REQUEST FOR INFORMATION DATE: May 04, 2017 NO.: RFI-530

Project Name: 15051-Webster University Interdisciplinary Science Building Project No.: 15051

Subject: Navy Island Soundply

PLAN DETAIL AT EXTERIOR CURTAINWALL LECT HALL

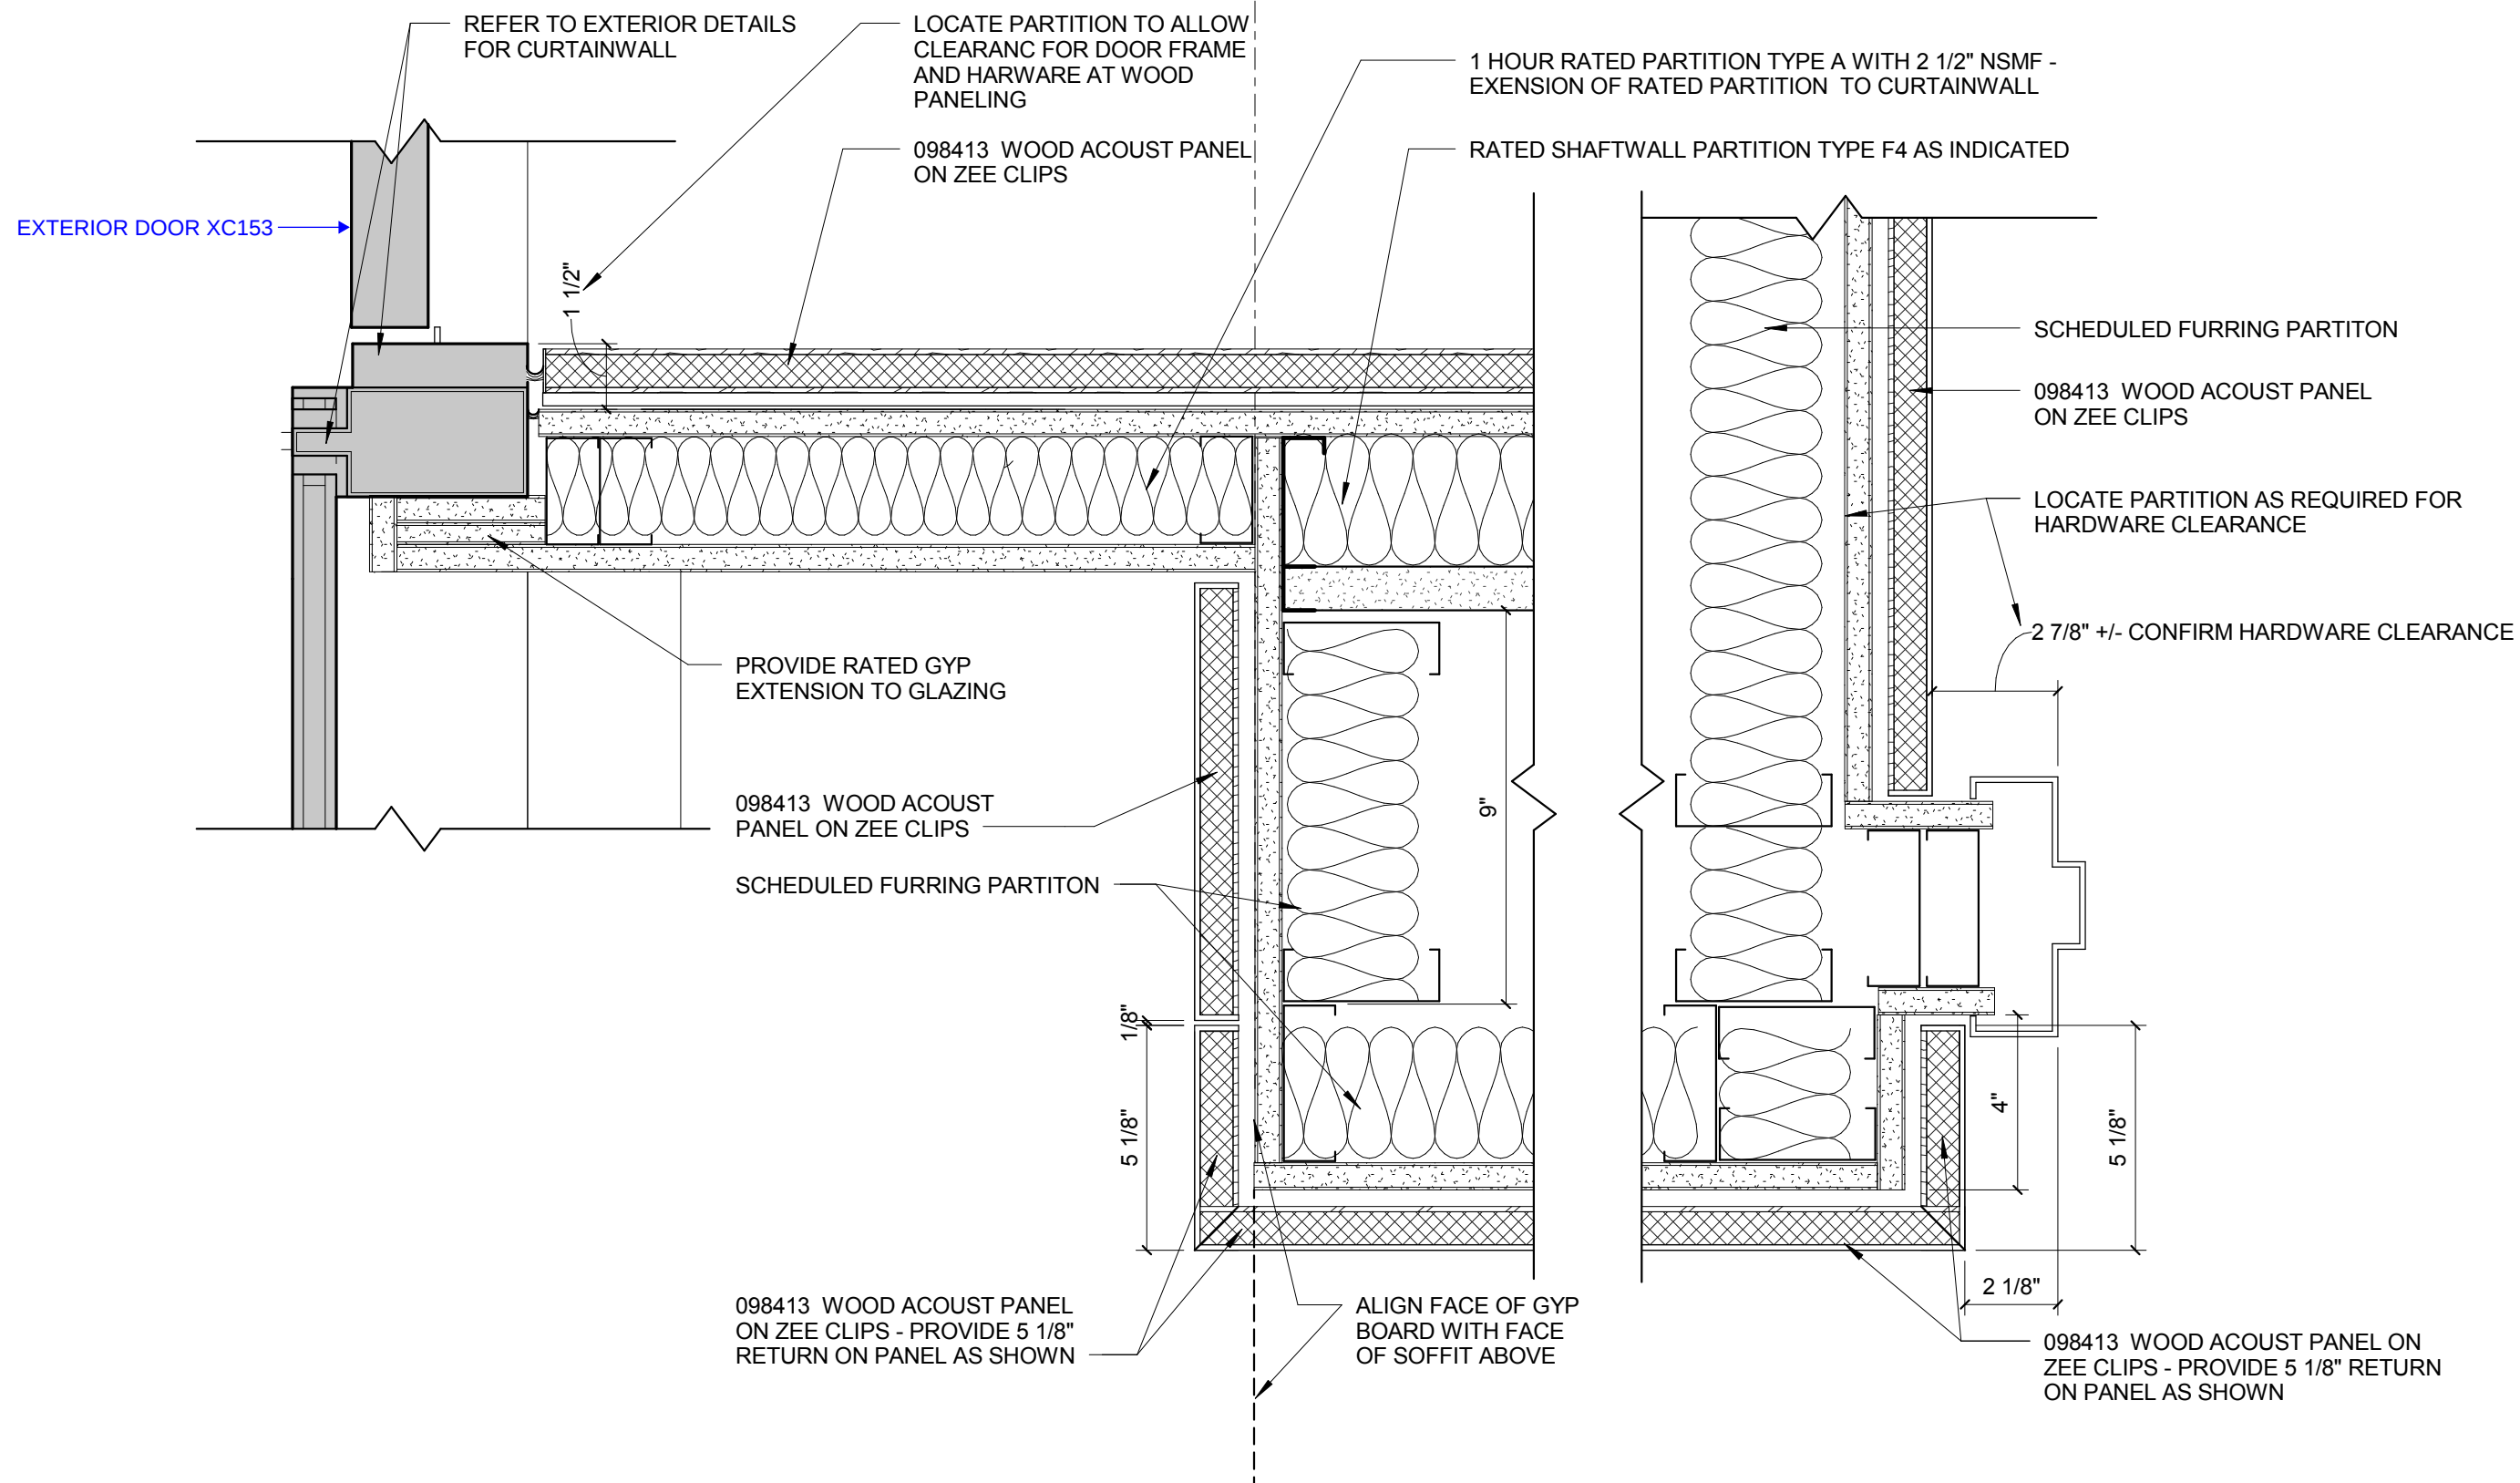
2) Regarding the 1/8" reveal vs. the 1/4" reveal:

Our expansion/contraction data suggests that 1/8" is fine. However, when you add up the extremes of 1) Expansion/contraction 2) Squareness Tolerance and 3) Installation Tolerance, you could get 1/8" reveals that look "off".

We will still warrantee all other aspects of the product, but we will need to make note on the drawings/warranty that the maximum amounts of the expansion and squareness tolerance could result in a negative appearance.

1. Navy Island standard perforations are acceptable.
2. We would like the 1/8" reveal - Confirm the the substrate is properly prepared and square for a good installation.

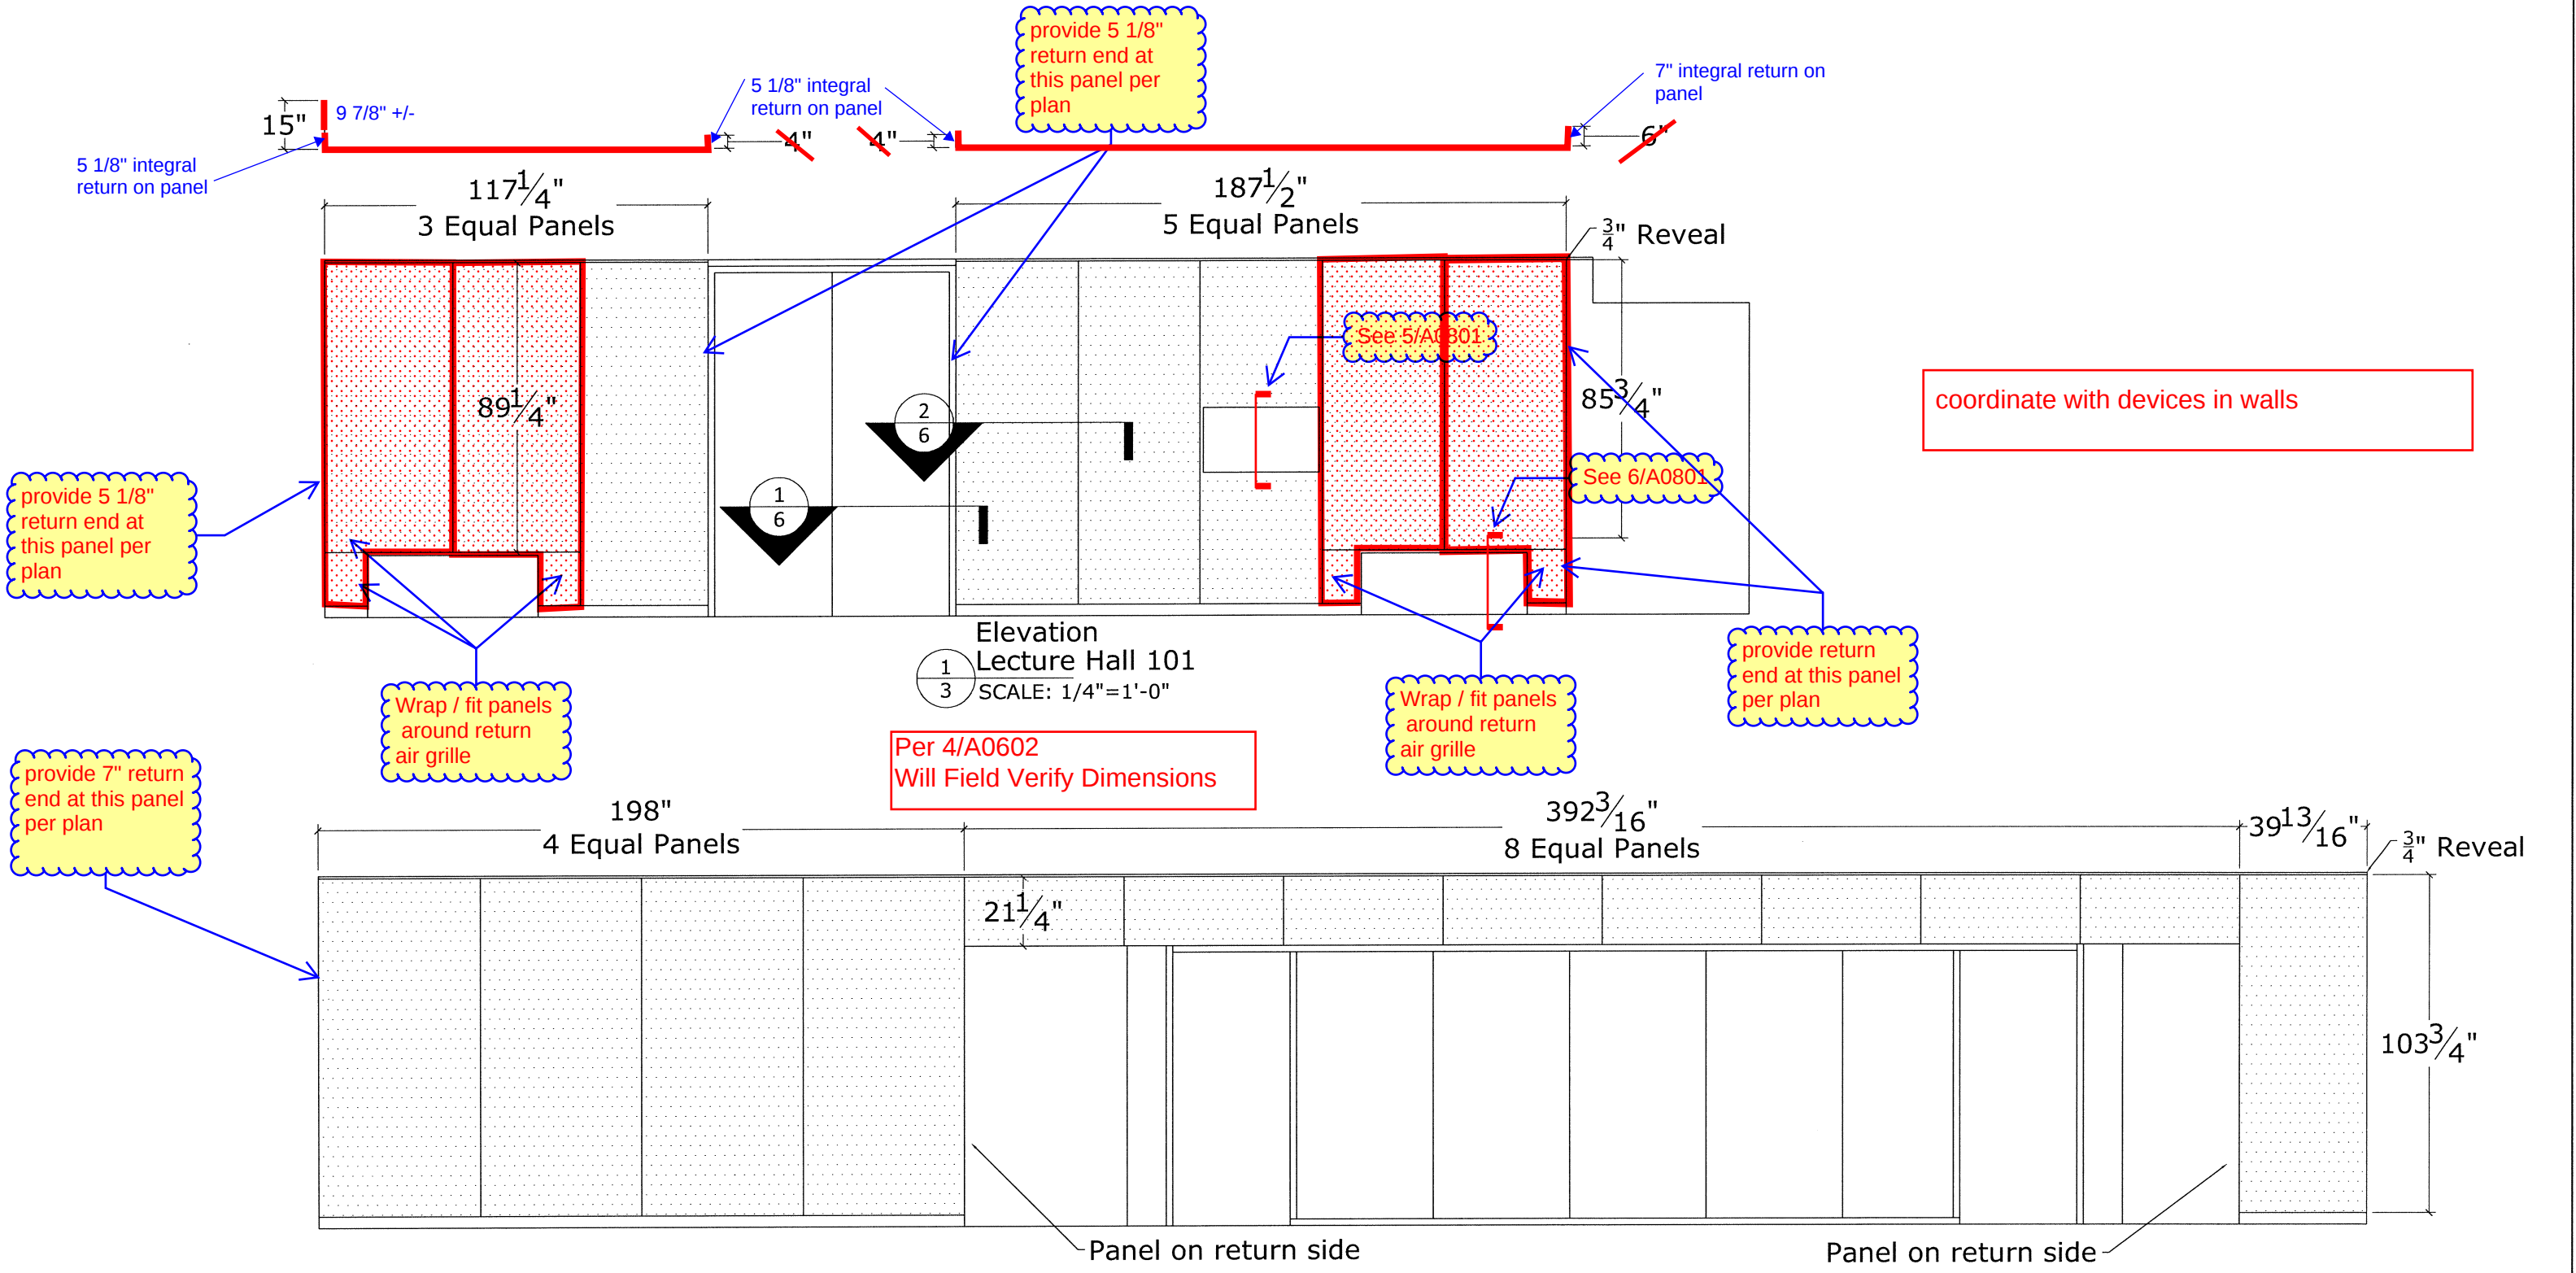
Provide return on this panel - refer to details

The yellow bars on this sheet diagrammatically show the design intent for the orientation / location of the outside corner joints for these panels.

Provide returns on both sides of this panel - refer to details

The designation numbers on this elevation tag are reversed.

Provide 5 1/8" returns on all these panels - refer to details

The designation numbers on this elevation tag are reversed.

2
6 ~~1/4~~"Reveal (Typ)
Typical Detail
Butt Joint
SCALE: No Scale

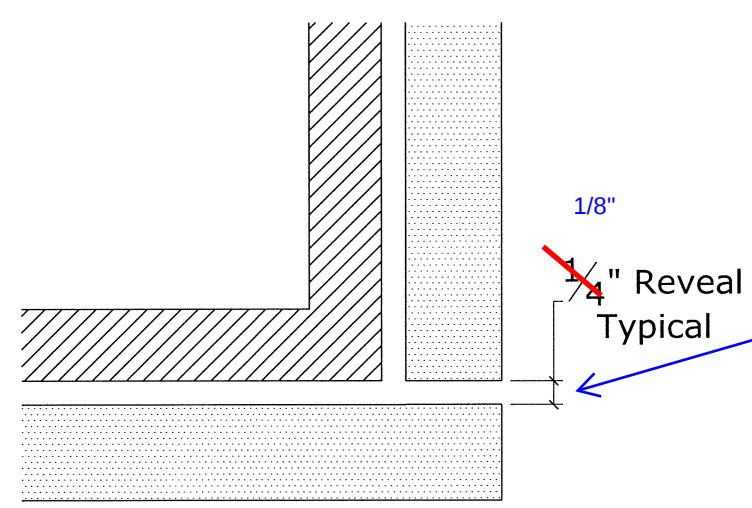
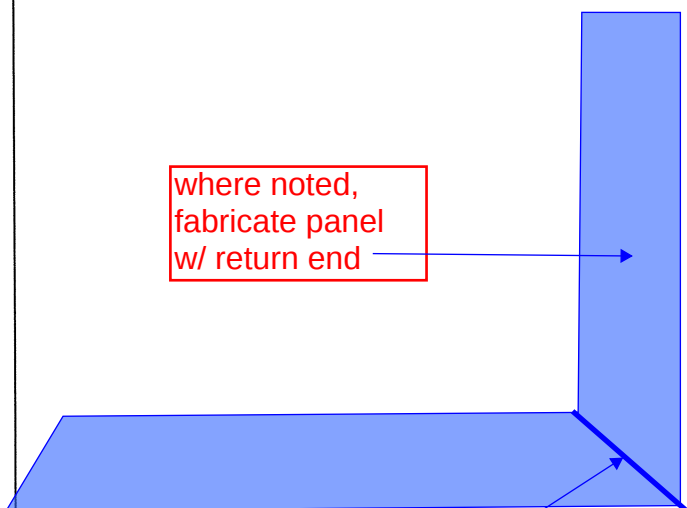
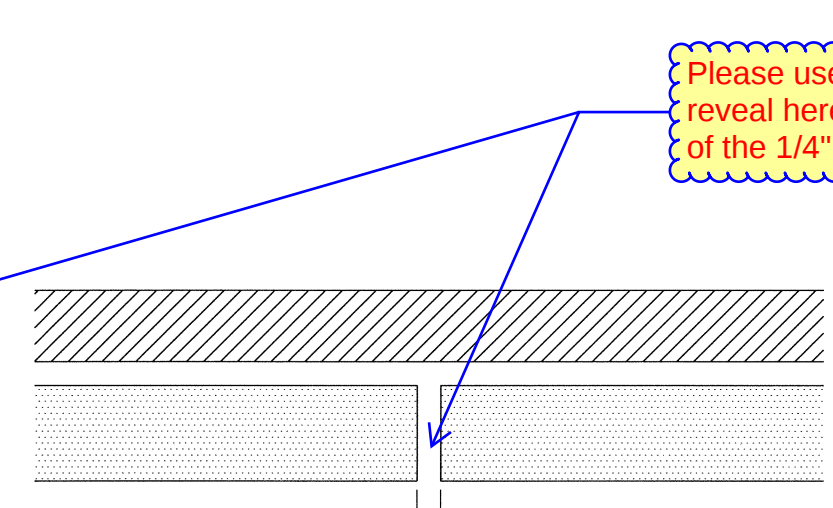
1. Specified product cannot be manufactured to have a 1" border without perforations. Reference email from Navy Island rep for more details. Please confirm this is acceptable. Product will look like the sample that was previously approved.
2. Navy Island rep has mentioned that using the 1/8" reveal ILO the 1/4" reveal could allow the panels to look off-center. Reference email for details. Please confirm whether you want the 1/8" reveal or the 1/4" reveal.

Please use 1/8"
reveal here instead
of the 1/4" reveal.
